September 9, 2026
7:00 PM
Planning Board Agenda

Continue Public Hearing and continue review of application for Amended Site Plan Approval, 393 Fishkill Avenue, 397 Fishkill Avenue, and 7 Conklin Street, Mix-Use Commercial and Residential, submitted by 397 Fishkill Avenue, LLC and 393 Fishkill Avenue, LLC.

Re: 393-397 Fishkill Avenue, Beacon, New York
Amended Site Plan Application – Responses to Comments

Below please find our responses to the comments included in KARC Planning Consultant's Memorandum, dated May 11, 2026. Please see responses and refer to Hudson Land Design's response letter regarding Lanc & Tully's letter dated May, 2026.

3 ELEVATION - MECHANICAL ENCLOSURE SCREENING

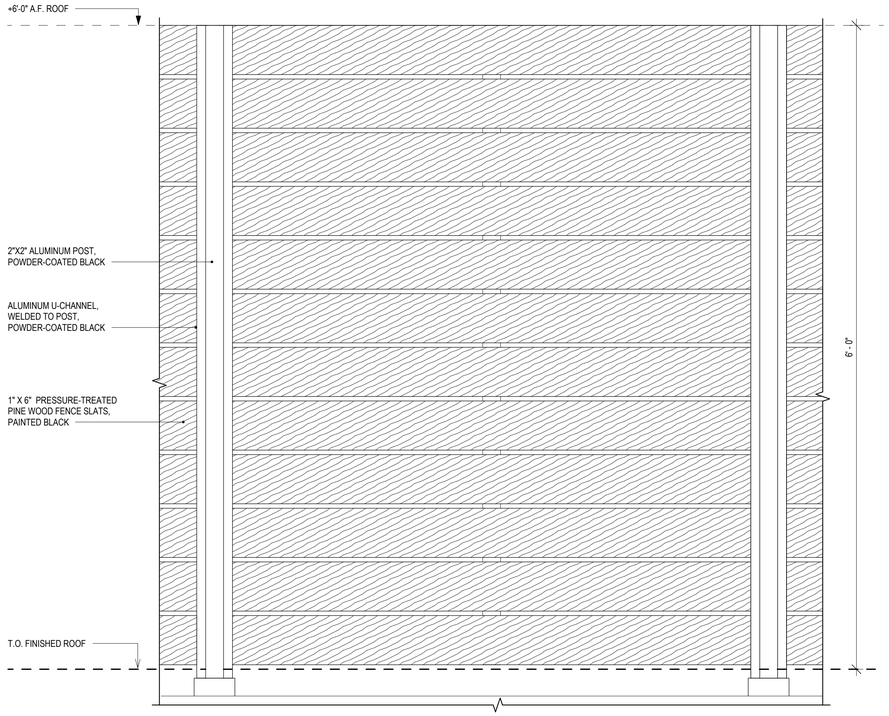
The rooftop mechanical enclosure screening has been a long-standing issue and the subject of multiple conversations throughout this project, and we want to make sure it is handled correctly and in a manner that fully addresses the Board's prior comments. To that effect, we have added a dedicated sheet to the architectural drawings, Sheet A-500, which provides detailed elevations for the proposed screening, including a full east-to-west section as requested at the August Planning Board meeting. In addition, the drawings now specify the materials for the posts and wood slats, as well as the proposed paint finish for the screening.
